Subject: EM-CING-130-200925 - 133 Horse Fence Hill Road, Southbury, CT - CT2126/LTE 5C

Re: ATC Site Name: SOUTHBURY

AT&T installed at the telecommunications facility at the above location. We have reviewed the provided construction photos and As-Built Drawings and have provided comments on the installation in the following summary. The installation was found to be in compliance with the issued construction drawings and applicable building codes.

## As-Built Drawings & Revised Mount Modification Drawings

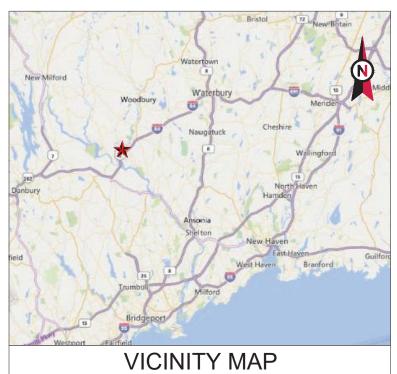
Photo	Description
2126 BETA POS 1 156 AZ 135 M .T. 0	Description: Antenna Tape Drop:  • Installation at RAD 156'  Note: Construction drawings depict a RAD of 153'  Recommendation: No Action Required
	Description: Installation of Equipment:
	<ul> <li>Description: Installation of Equipment:         <ul> <li>(1) new antenna and (2) new RRHs (typical all sectors)</li> </ul> </li> <li>Recommendation:         <ul> <li>No Action Required</li> </ul> </li> </ul>

TOWER ELEVATION

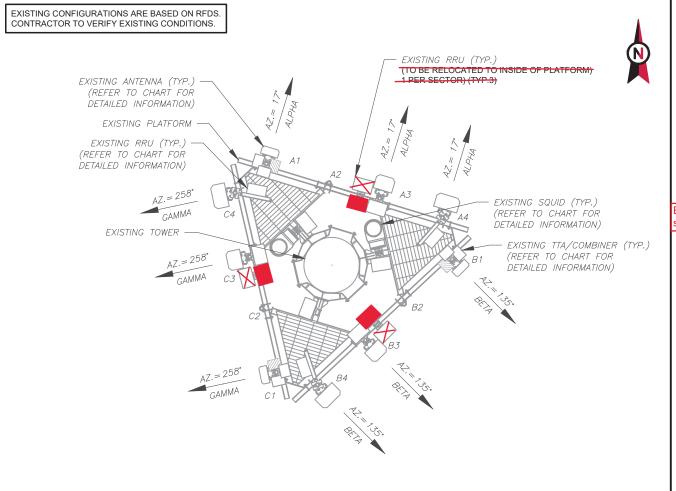
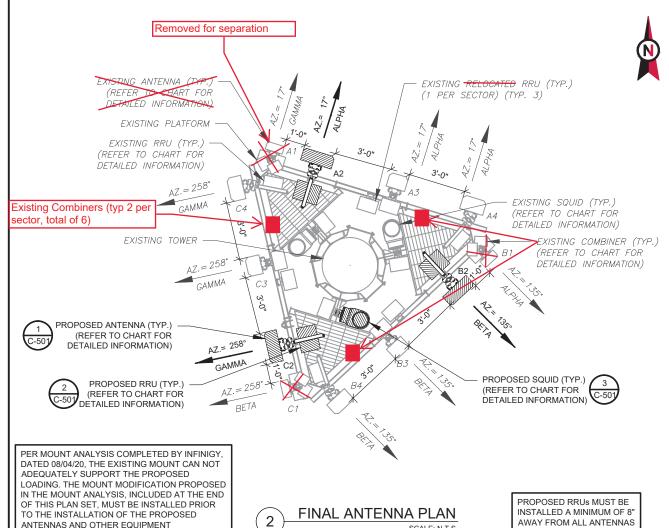
- New antennas were installed at 156', while CDs depict a RAD of 153'.
- (3) antennas were removed. However, this was not indicated in the CDs.
- As-built CDs include mount modifications. However, revised mod drawings were issued based on reduced loading.
- These items have been reviewed by the EOR and no action is required.
